TOWN OF GREENVILLE  
ORDINANCE NO. 2013-WR-007

**RESOLUTION CONCERNING THE AUTHORIZATION BY A MAJORITY  
VOTE BY THE GREENVILLE WATER UTILITY COUNCIL FOR  
SIGNAGE OF THE HERITAGE SPRINGS WWTP SALES CONTRACT BY  
TALBOTTE RICHARDSON COUNCIL PRESIDENT WITH THIENEMAN  
ENVIRONMENTAL LLC**

## Heritage Springs Wastewater Treatment Plant Review

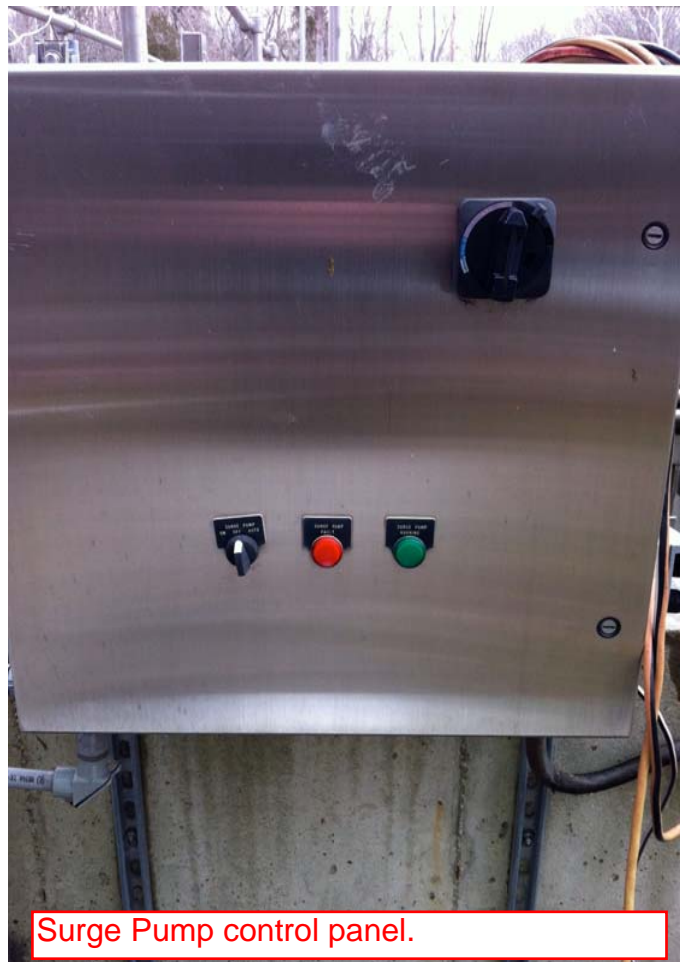
Manhole steps to access tank walkways.

Recommendation	Benefit
Add handrail around the top and west edge of the outfall cascade.	Improve safety.
Add stairs to access plant walkways in lieu of cast-in-place manhole steps.	Improve access.
Confirm grating is on the UV structure for compliance with OSHA fall protection. Add grating or handrail if missing.	Improve safety.
Install fine bubble diffusers in lieu of coarse bubble diffusers (check blower and air filtration impacts first).	Improve oxygen transfer and overall efficiency and enhance permit compliance. Not an immediate concern.
Improve outfall cascade to transfer more oxygen at low flows.	Enhance permit compliance.
Carefully monitor influent concentrations since they are above design concentrations. Design BOD is 240 mg/L, actual has been 316 mg/L. Design NH <sub>3</sub> -N is 25 mg/L, actual has been 41 mg/L.	As WWTP approaches design flows, the plant may run out of oxygen transfer/treatment capacity. Not an immediate concern.
